SECTION 106 – DETERMINATION OF EFFECTS:

Preliminary Design -- North Approach Spans, Continental Avenue Viaduct

Dallas County: CSJs # 0918-45-121

Trinity Parkway

Figure 2-23. Type C411 Rail

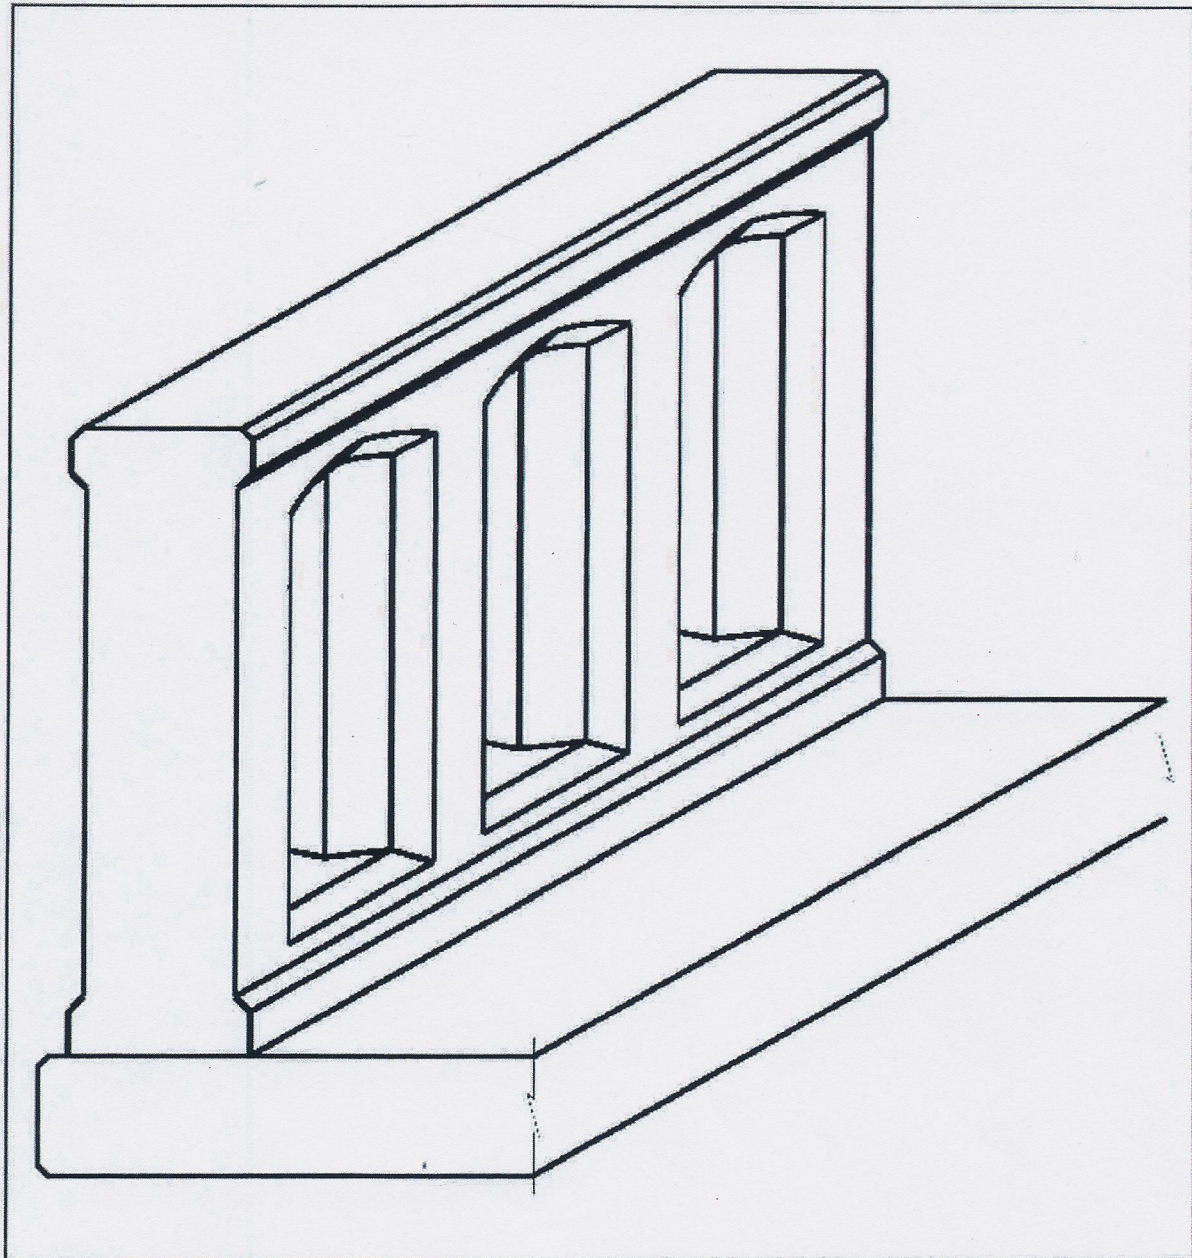
The two replacement arched spans atop the levee along with their C411 rail will stand as visually compatible units with the historic floodway segments of the viaduct. The three concrete girder spans with their T401 rail will stand as a compatible yet distinct unit within the viaduct denoting their recent construction. The location of these spans on the land side of the levee ensures they will be viewed as a separate, less prominent segment of the viaduct when compared to the floodway portion of the historic structure.

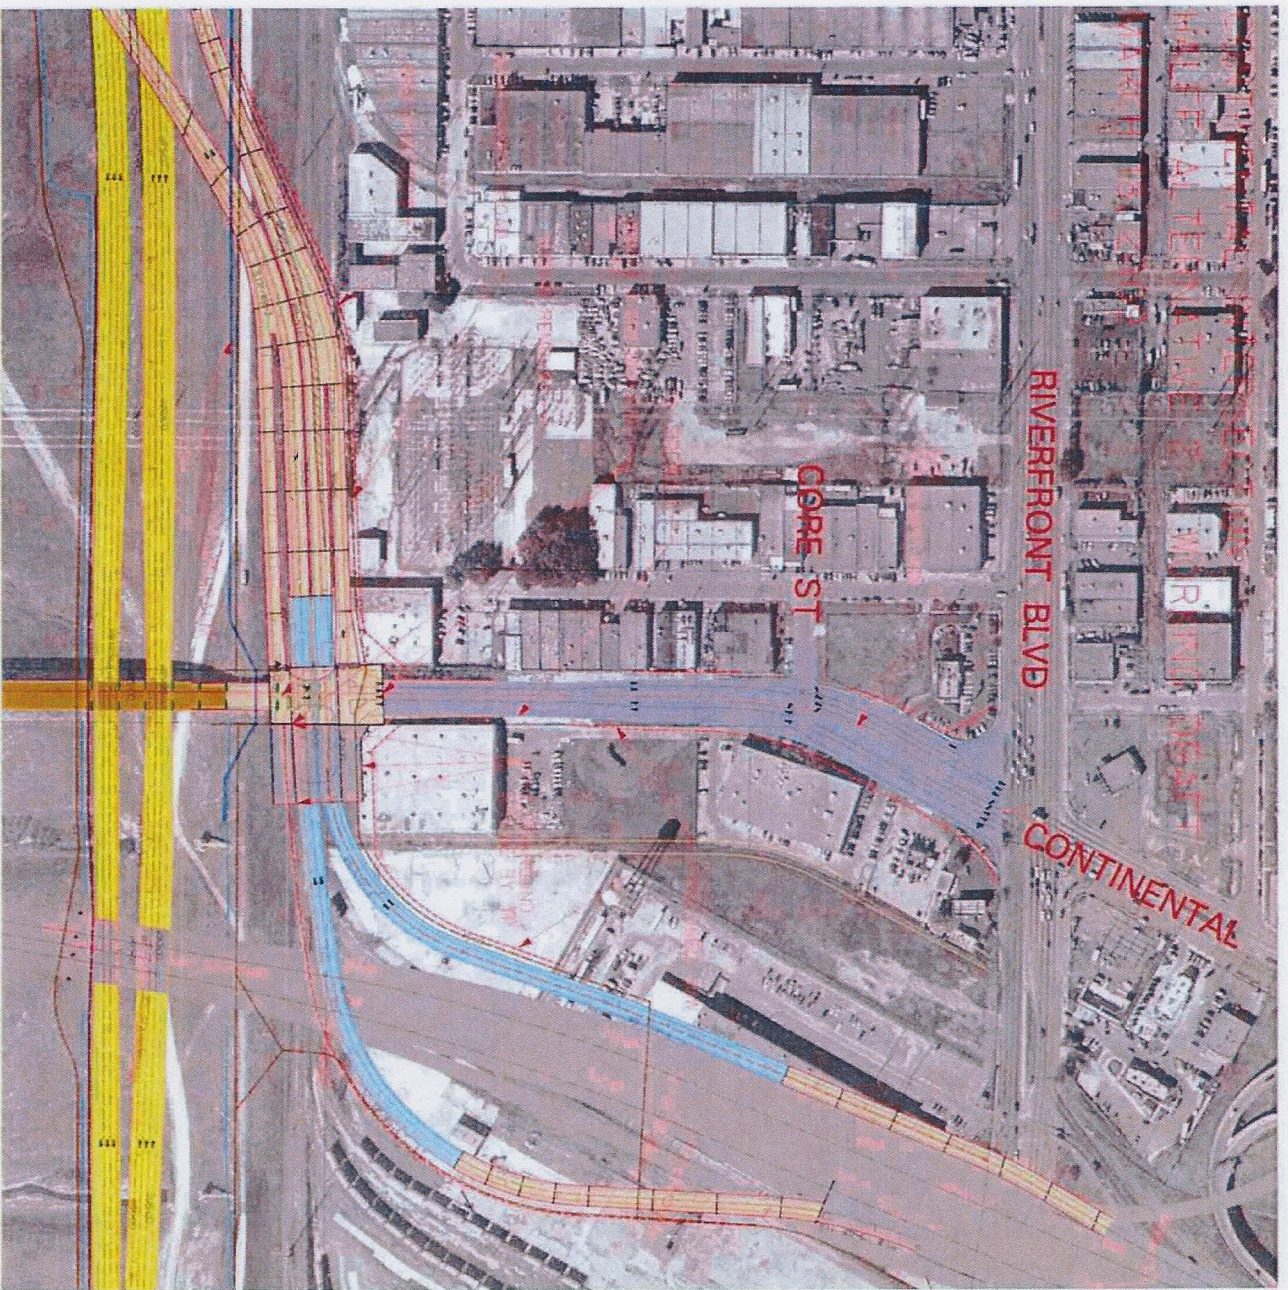
The attached preliminary design for the approach span replacement is composed of two arched segments atop the existing East Levee and three pre-stressed flat girder unit spans extending beyond the land side of the levee. Both the arched and pre-stressed girder spans would be constructed in concrete to reflect the material of the historic viaduct. Due to their visibility from the floodway, the two spans atop the levee are proposed as arched structures to better blend with the rest of the historic viaduct. The proposed C411 open rail, while not identical to the historic rail, would still blend compatibly with the rest of the viaduct.

The three pre-stressed girder spans would not be viewed from the floodway, as the levee acts as an obstacle deterring a visual linkage with the floodway portion of the structure. A narrow girder span stands atop the land side slope of the levee, while the remaining two spans are wider to allow for the at-grade connector ramps and a levee operations and maintenance road (see attached bridge layout plan). The proposed T401 rail for these spans would reflect the contemporary appearance of this new segment of the viaduct.

We note the possibility of preserving a historic arch span on the floodway side of the levee. Such an option, however, would not be viable unless the US Army Corps of Engineers (USACE) determines that the proposed diaphragm wall within the river side of the levee is not required (see attached bridge layout elevation sheet). If FHWA selects Alternative 3C in the upcoming Record of Decision (ROD) for Trinity Parkway, the diaphragm wall issue will not be resolved until the final project design phase leading up to the anticipated Section 408 construction approval from the USACE. Given this lengthy time frame and our current request for your comment on the attached preliminary design, preservation of the historic arched span cannot be presented to your agency as a viable option at this time.

**CONCUR:
PRELIMINARY DESIGN -- CONTINENTAL AVENUE VIADUCT
NORTH APPROACH SPANS**
